RE: Proposed Warehouse Building Presumpscott Street ID #2004-0104, CBL #419-A-007

Review letter date 07/01/04 by Kandice Talbot, Planer:

RE: Approx 435 Presumpscot Street – Warehouse Building, Kevin McQuinn

DATE: July 12, 2004

Pond 1P: WETLAND/POND IN CONCRETE OUTWASH

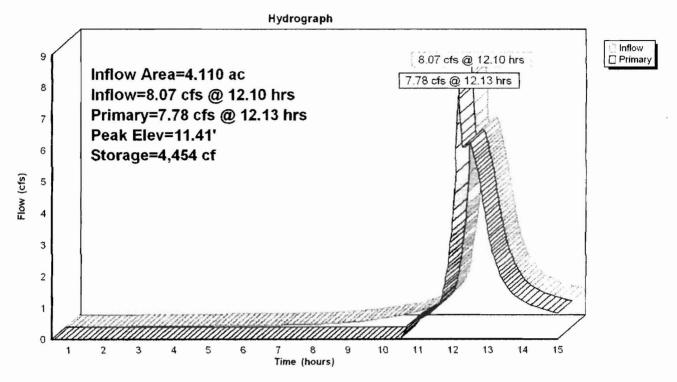
A. The bottom of the site appears to be a wetland or ponding area, which is acting as a form of detention. The engineer shall review and model the site with this as a pond. The detention pond area needs to show the various stage storage levels for each design storm. The outlet control for the ponding area indicates that an existing culvert under the railroad is the only outlet available. What are the invert elevations, culvert size, and inlet condition? It appears from the survey that the culvert is the actual property corner and is not offsite. Please verify.

The stormwater model has been revised to represent a wetland/ponding area at the northeast corner of the site. Scott McLaren delineated the wetland based on the three Army Corp criteria (hydrology, vegetation and hydric soils). The culvert at the northeast corner of the site is the controlling structure for this site and other off site watersheds to the north. What we are demonstrating is that our site has no impacts on that structure as it relates to our property line. In the end result the 25-year event has an insignificant increase of 0.19 CFS that also passes through the culvert ~6 minutes earlier than the rest of the watershed feeding it. It is my conclusion that because we be the peak ever so slightly, have an insignificant

change in quantity, and are directly tributary to the bay, that the project is acceptable and detention or attenuation is neither warranted nor practical.

Pond 3P: NEW 6' DIAM. TWIN GRATE CB

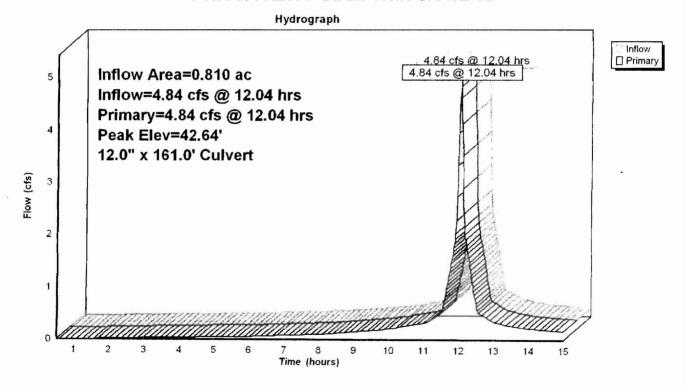
C. The pipe velocities that will be generated from the site will be substantial given slopes in the 20% or higher grade. We feel that the riprap outlet apron shall be designed for the 25 yr storm with supporting calculations. Our concerns are that the outlet not be blown out by the outflow energy produced from the proposed pipe. (Also the model is not showing the same elevation and slope as the plan)

The stone lined plunge poll has been replaced with a 6 foot diameter catch basin sump for energy discipitation. The inside of the basin is lined with a stainless steel plate opposite the inflow to prevent corrosive action on the concrete. The sump has holes in the bottom to relieve any upward pressure and to allow it to drain out. Discharge will enter the sump and then flow out over a stable rock apron.
